SUBJECT: THP 1-09-058-SON Codorniu Napa (Artesa-Fairfax) post-Preharvest Inspection THP comments

LETTER 29: PETER BAYE, BOTANIST, COASTAL PLANT ECOLOGIST

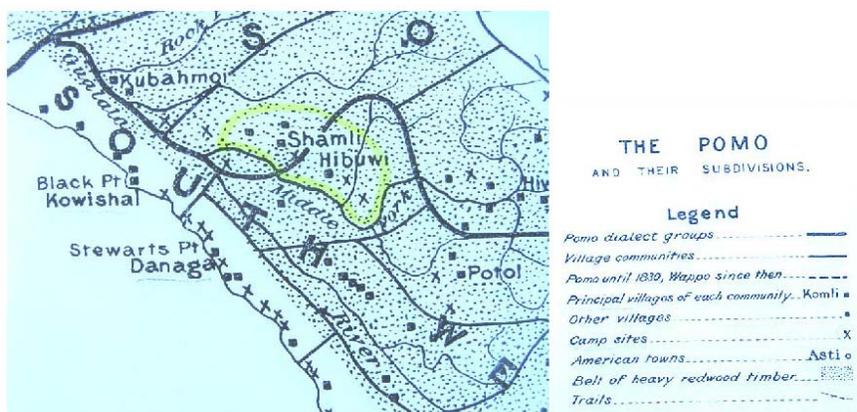
38-28
 Cont'd

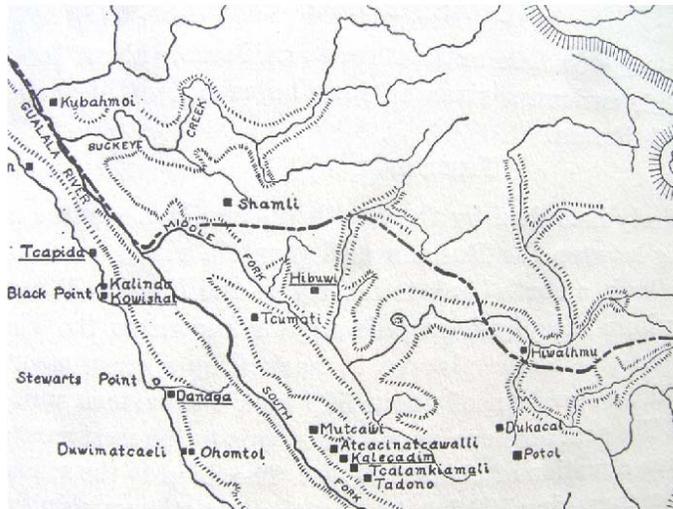
38-28
 Cont'd
